United States Patent and Trademark Office

APPLICATION NO.	FILING DATE	FIRST NAMED INVENTOR	ATTORNEY DOCKET NO.	CONFIRMATION NO.
10/797,518	03/09/2004	Martin Burgbacher	870-003-172	4224
4955	7590 12/27/2005	EXAMINER		
WARE FRESSOLA VAN DER SLUYS & ADOLPHSON, LLP BRADFORD GREEN BUILDING 5 755 MAIN STREET, P O BOX 224 MONROE, CT 06468			nguyen, hanh n	
			ART UNIT	PAPER NUMBER
			2834	
			DATE MAILED: 12/27/2005

Application No.	Applicant(s)			
055 4-4' 0	10/797,518	BURGBACHER, MARTIN			
Office Action Summary	Examiner	Art Unit			
	Nguyen N. Hanh	2834			
The MAILING DATE of this communication appears on the cover sheet with the correspondence address Period for Reply					
A SHORTENED STATUTORY PERIOD FOR REPLY IS SET TO EXPIRE 3 MONTH(S) OR THIRTY (30) DAYS, WHICHEVER IS LONGER, FROM THE MAILING DATE OF THIS COMMUNICATION. - Extensions of time may be available under the provisions of 37 CFR 1.136(a). In no event, however, may a reply be timely filed after SIX (6) MONTHS from the mailing date of this communication. - If NO period for reply is specified above, the maximum statutory period will apply and will expire SIX (6) MONTHS from the mailing date of this communication. - Failure to

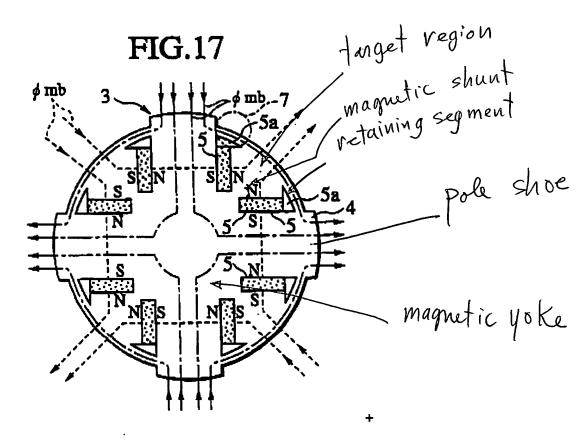
Regarding claim 1, Sakai et al. disclose an electric motor which comprises: a stator (Fig. 2) having a polyphase stator winding (Col. 2, lines 15-40); a rotor (3 in Fig. 17), separated from the stator (1) by an air gap (Fig. 2), which has on its side facing toward the air gap a plurality of salient poles with pole shoes facing the air gap and, on its side facing away from the air gap, a magnetic yoke, whose pole shoes (a protruding region in Fig. 15B) serve to generate a sinusoidal induced voltage in the stator winding: a recess (5), provided between the magnetic yoke and a pole shoe, in which at least one permanent magnet (6) is arranged, which recess (5) is adjoined on each side of the at least one permanent magnet (6), approximately in the circumferential direction, by a low magnetic conductivity region (5a) that adjoins, on its side facing toward the air gap. a retaining segment (please see markups) made of ferromagnetic material, which segment serves to connect the pole shoe mechanically to the magnetic voke; and at least one magnetic shunt (please see markups) that extends from a source segment, located closer to the air gap, of the at least one permanent magnet (6), through a low magnetic conductivity region adjacent to that segment to a target region (please see markup) of the relevant retaining segment in order to inject at that target region an additional magnetic flux from that permanent magnet (6).

Regarding claim 5, Sakai et al. also disclose an electric motor wherein a magnetic shunt (please see markups) extends to a target region that is connected to the

Regarding claim 6, Sakai et al. also disclose an electric motor wherein a magnetic shunt (please see markups) extends to a target region that is connected to the magnetic yoke via a part of the retaining segment that is at least locally saturated during operation (Col. 9, lines 5-9).
